City of Piedmont
COUNCIL AGENDA REPORT

DATE: November 4, 2024

SUBJECT: Consideration of an Appeal of the Planning Commission's Decision to Conditionally Approve a Design Review Permit Application (DRPC2023-016) to Renovate and Add a Second Story to an Existing Single-Family Residence at 21 Cambridge Way

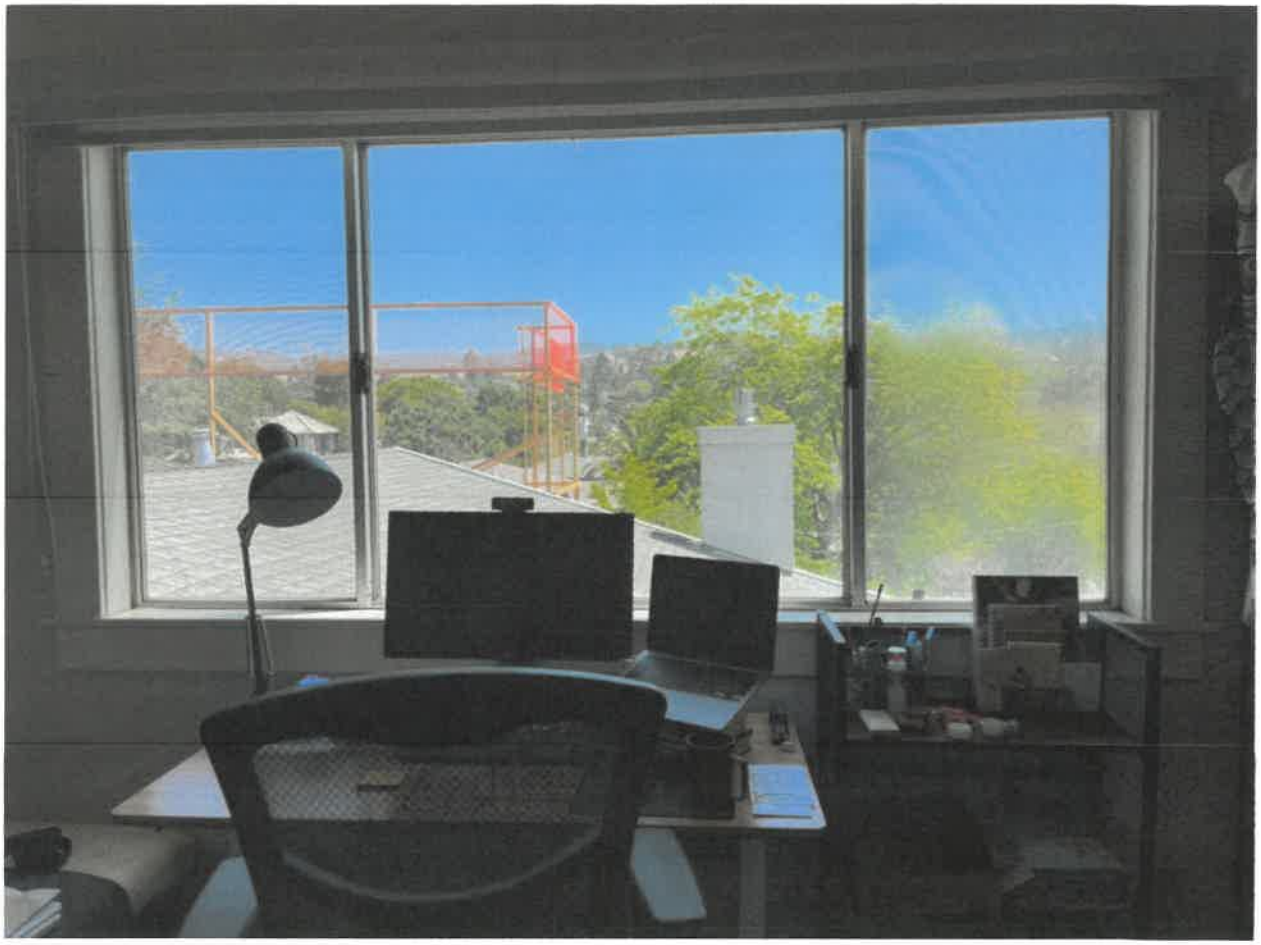
Photos of the views being obstructed are attached to this letter. The first photo is taken from the entrance doorway to the bedroom, which we are using daily as an office. This is not a secondary or tertiary room (it is not a bathroom or laundry room) and is not a view

that we can see from the front living room of the house. The second photo is from a bedroom on the first floor that is used by our son.

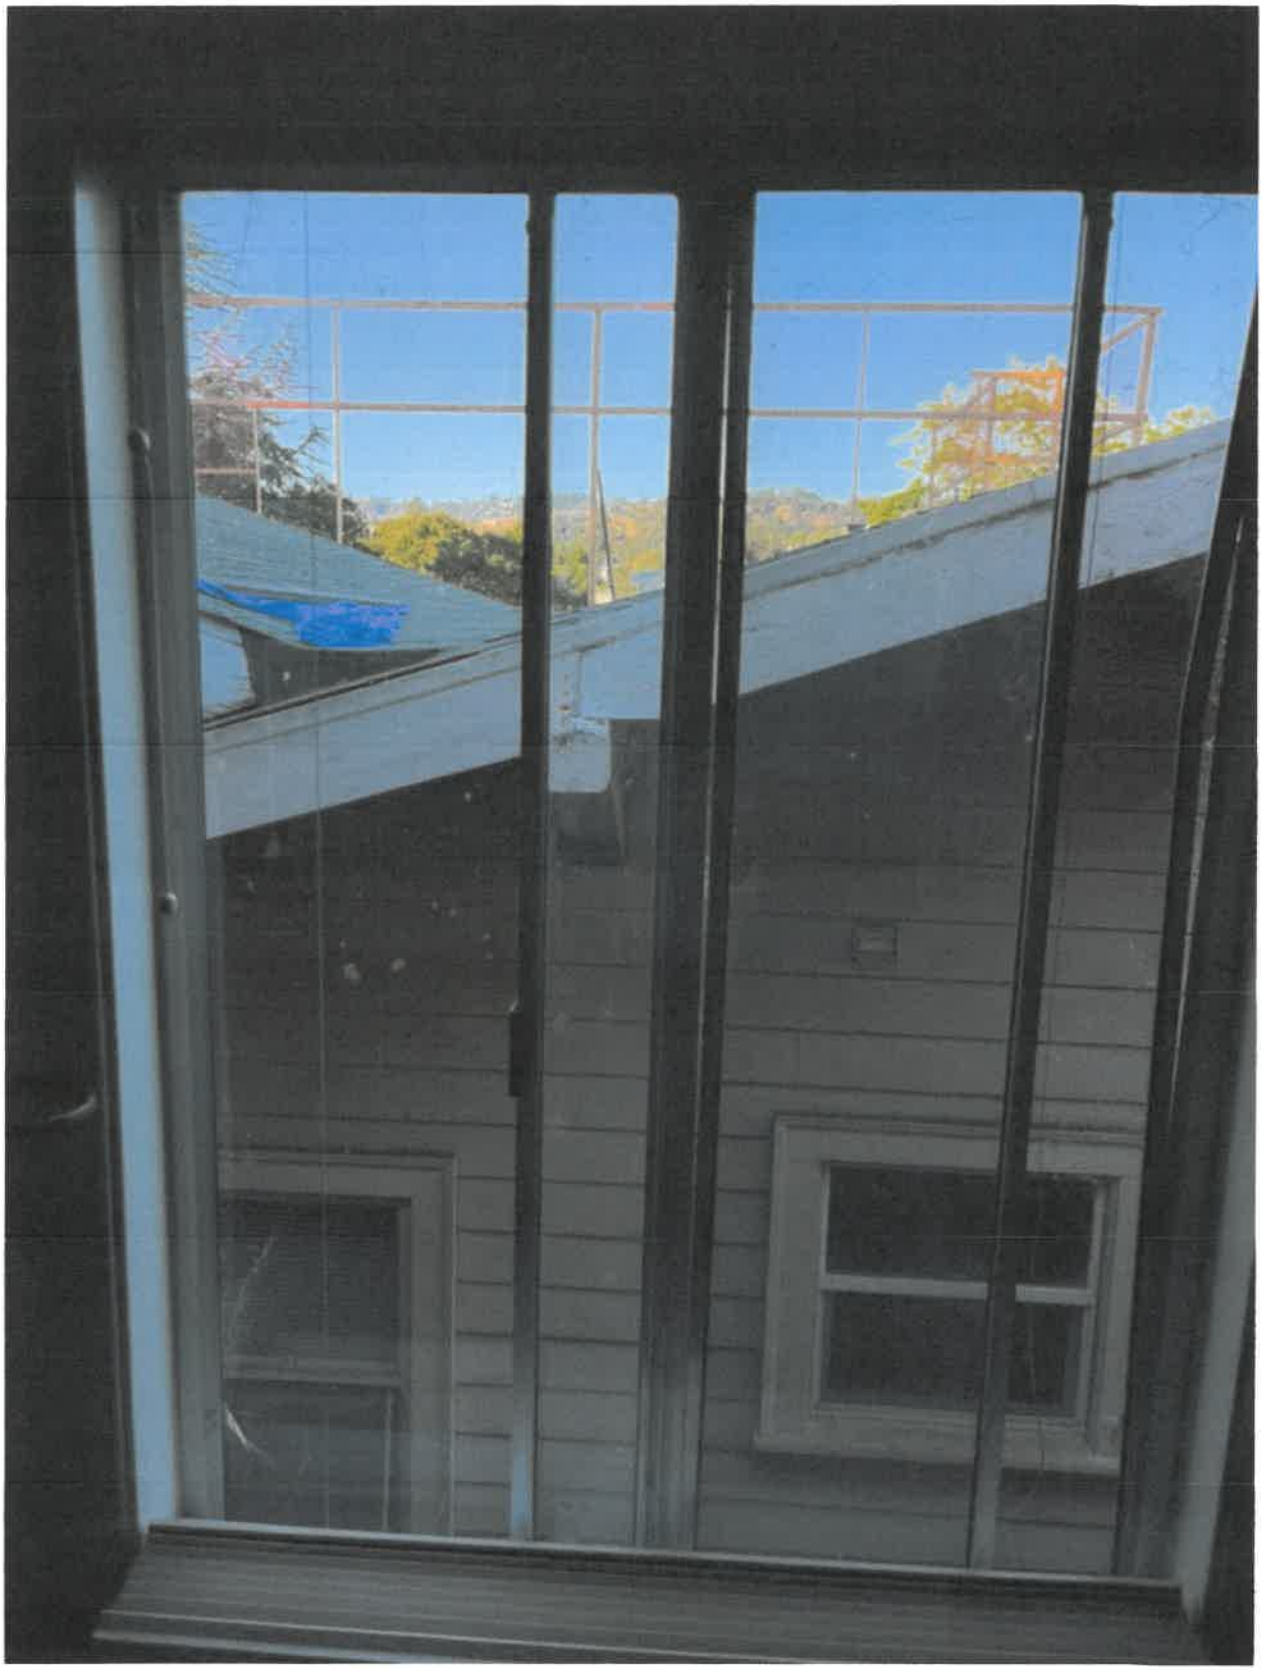
Under Section 5.01.01 addressing neighborhood compatibility, Piedmont's Design Guidelines state that "[o]n steeply sloping properties, it is important to minimize building bulk. This is accomplished by respecting existing topography and following the contours of the existing slope. "Stepping down" with the slope reduces the building's effective visual bulk and avoids the appearance of an excessively large, bulky building." The design comments further state that "[l]arge flat building planes should be avoided,'" and that "[b]uilding massing should be broken up into several horizontal and vertical elements."

The owner's current design for 21 Cambridge Way presents one mass and does not step the second story back at the front of the house. The current proposed design also includes extending the back of the house. The owner can maintain their desired square footage addition by increasing the horizontal addition on the first floor and the second floor above it at the rear of the house, while stepping back the second story addition at the front of the house. Stepping the second story back at the front of the house will follow the contour of the hill, reduce the massing and bulk from the street, and mitigate the impact on our existing views. To adequately mitigate the impact on our existing views, the new second story addition would need to be stepped back about half of its proposed length.

Photo of the balcony from our kitchen window - look into our kitchen window

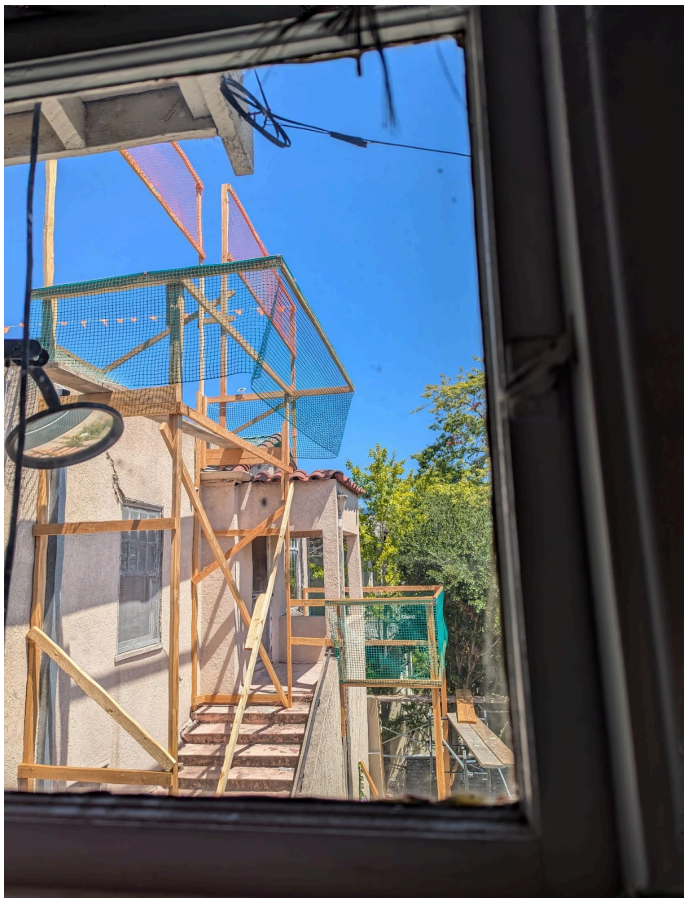
The proposed plan includes two huge front balconies, 7'x11' and 12.5'x8.5', and stairs extending towards the street that creates an oppressive towering structure. The second story balcony has a direct line of sight into our front living room and our dining room with only a few feet away/clearance; this is an absolute intrusion of our privacy. As indicated by the photos below, the second story balcony is clearly visible from our windows in the dining room, kitchen and living room. That means that people on the balcony can clearly see our activities in these areas. Imagine having people sitting/standing over there looking down directly down on your dining table. Imagine strangers peering over your shoulder in the comfort of your own house. Our privacy is obliterated by the proposed front balcony.

Photo of the proposed balcony from our dining room window - they can directly look down to our dining table

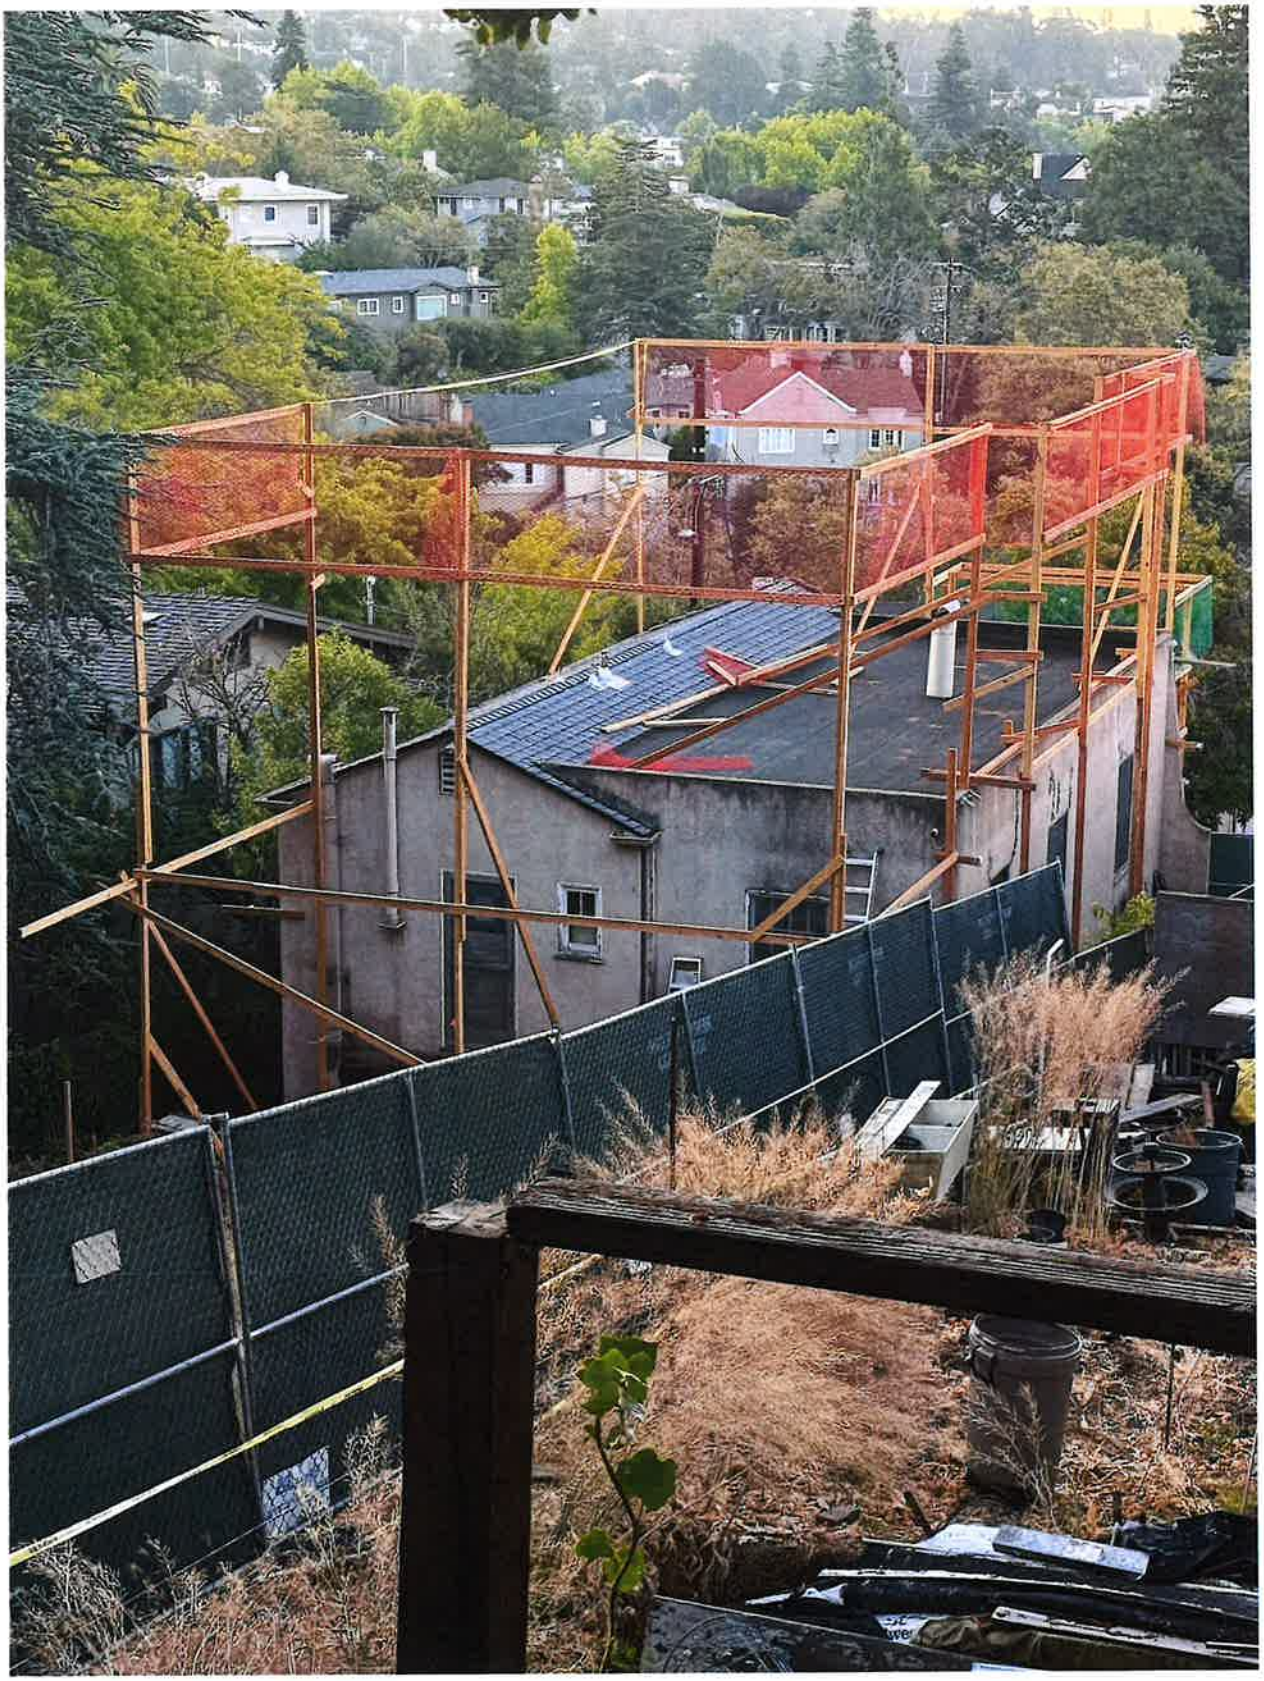
The proposed project is too large for location. Proposed project negatively impacts light, air & blocks view from backside of property. Project should be scaled down to reduce impact on neighboring properties. See Photos.

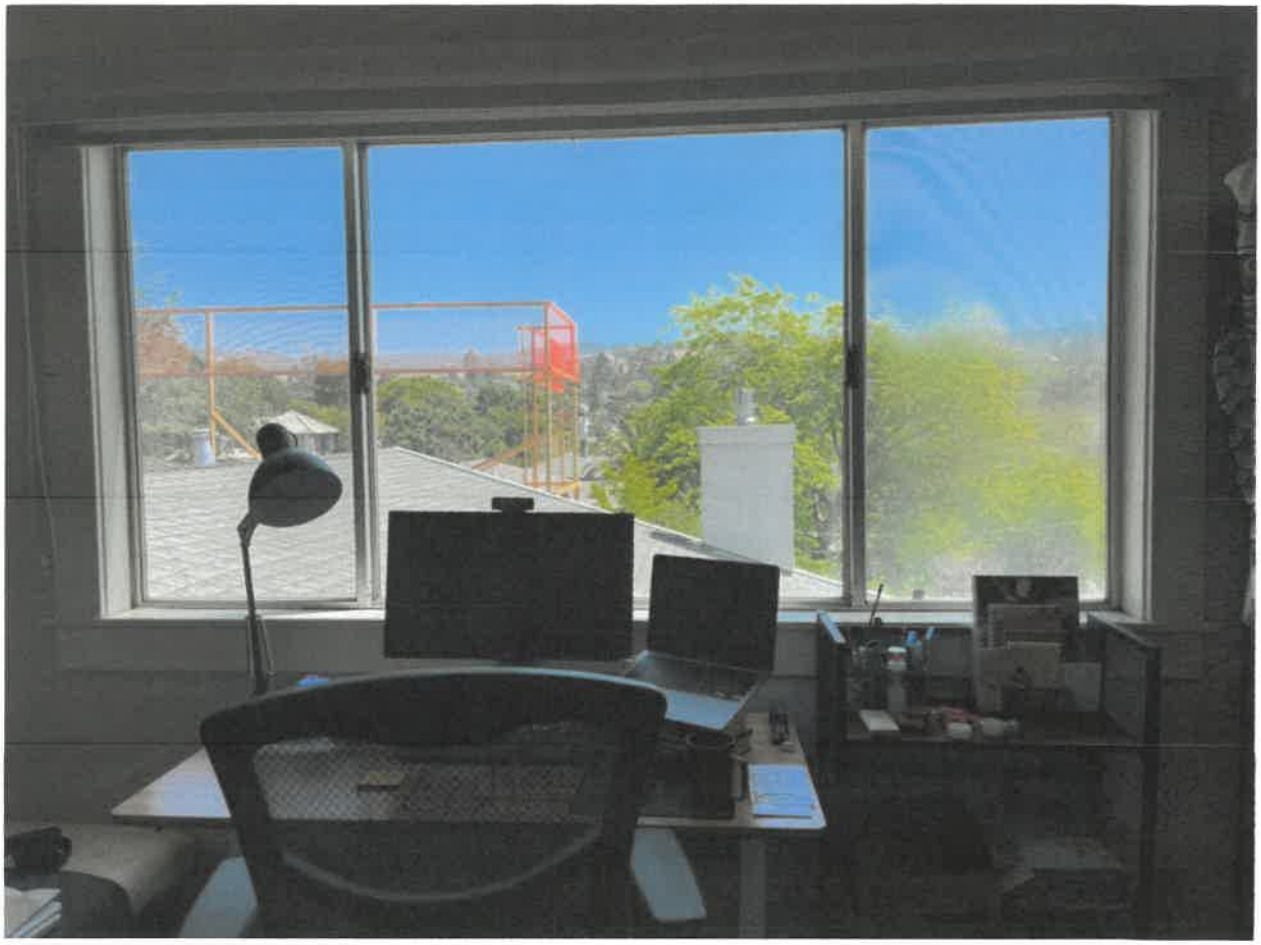
Photos of the views being obstructed are attached to this letter. The first photo is taken from the entrance doorway to the bedroom, which we are using daily as an office. This is not a secondary or tertiary room (it is not a bathroom or laundry room) and is not a view

that we can see from the front living room of the house. The second photo is from a bedroom on the first floor that is used by our son.

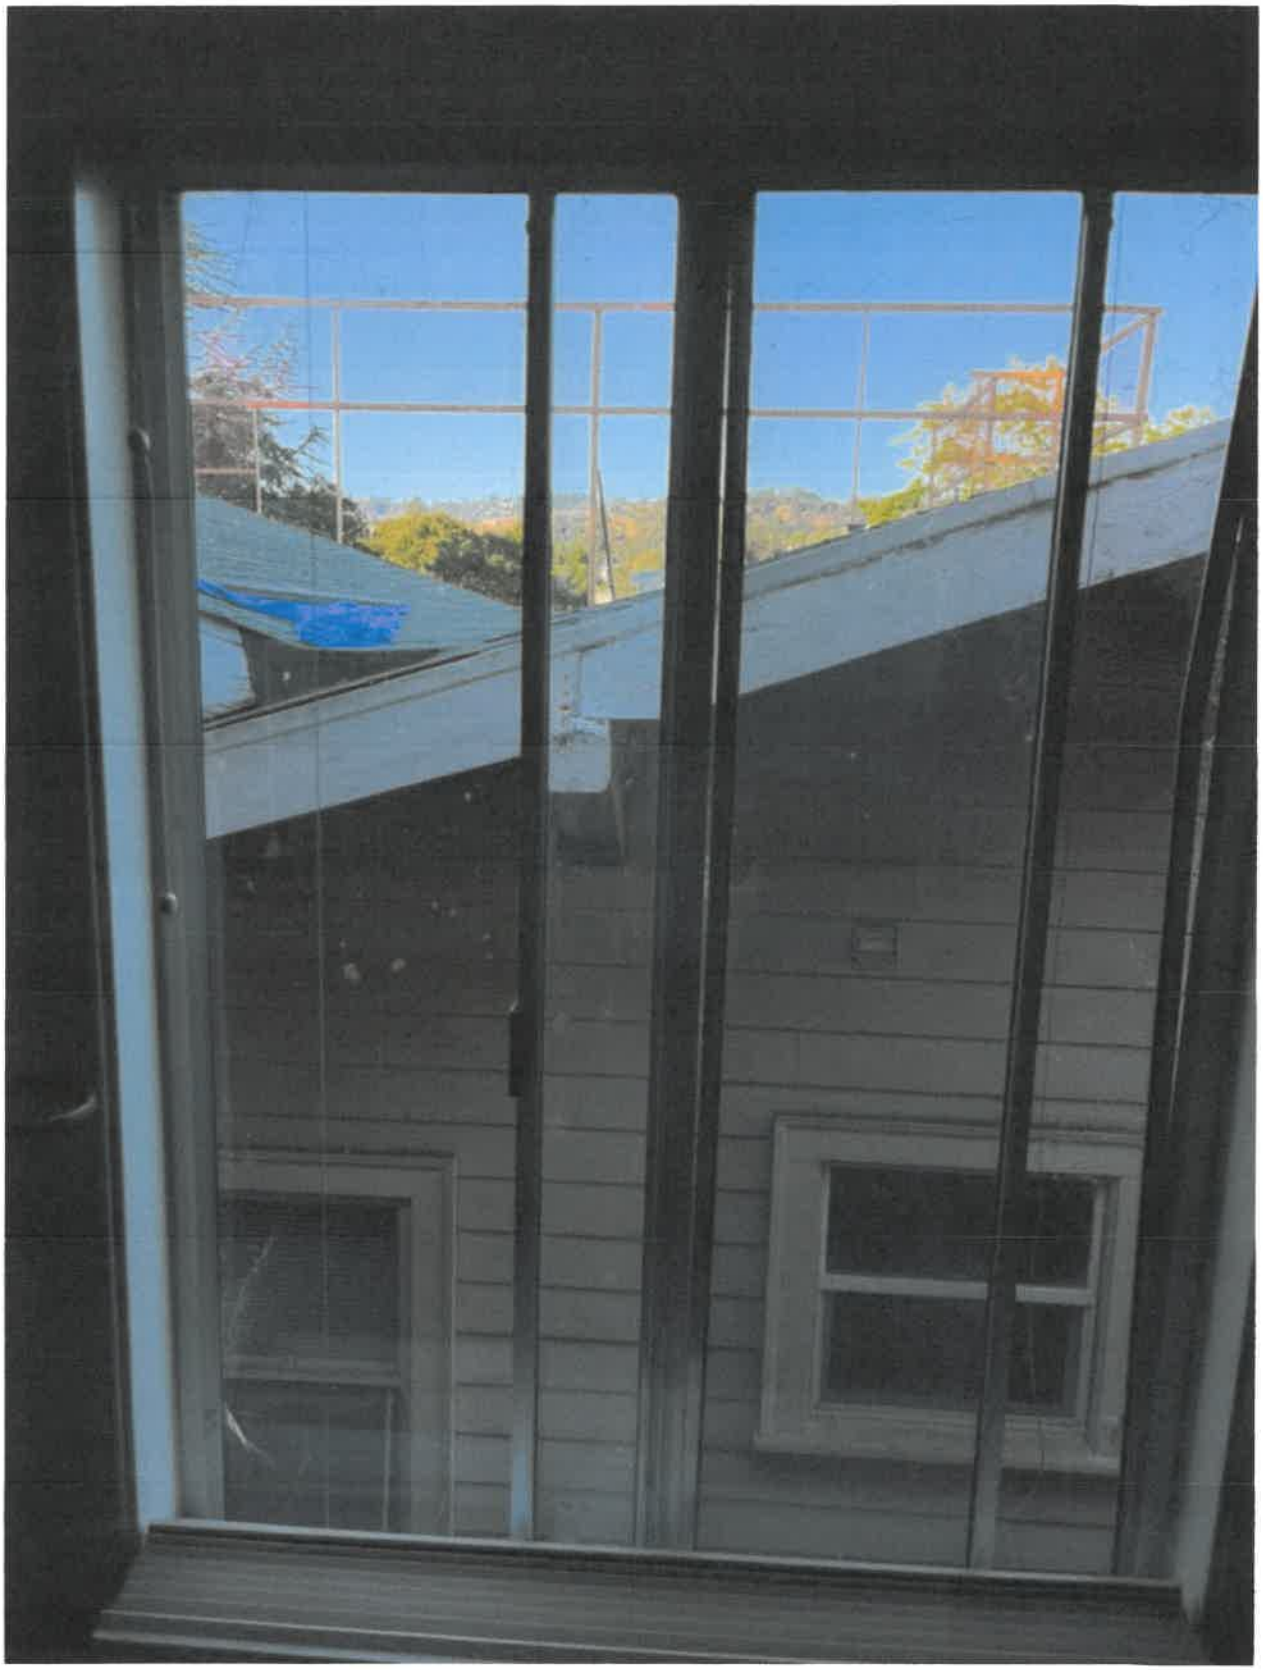
Under Section 5.01.01 addressing neighborhood compatibility, Piedmont's Design Guidelines state that "[o]n steeply sloping properties, it is important to minimize building bulk. This is accomplished by respecting existing topography and following the contours of the existing slope. "Stepping down" with the slope reduces the building's effective visual bulk and avoids the appearance of an excessively large, bulky building." The design comments further state that "[l]arge flat building planes should be avoided,'" and that "[b]uilding massing should be broken up into several horizontal and vertical elements."

The owner's current design for 21 Cambridge Way presents one mass and does not step the second story back at the front of the house. The current proposed design also includes extending the back of the house. The owner can maintain their desired square footage addition by increasing the horizontal addition on the first floor and the second floor above it at the rear of the house, while stepping back the second story addition at the front of the house. Stepping the second story back at the front of the house will follow the contour of the hill, reduce the massing and bulk from the street, and mitigate the impact on our existing views. To adequately mitigate the impact on our existing views, the new second story addition would need to be stepped back about half of its proposed length.
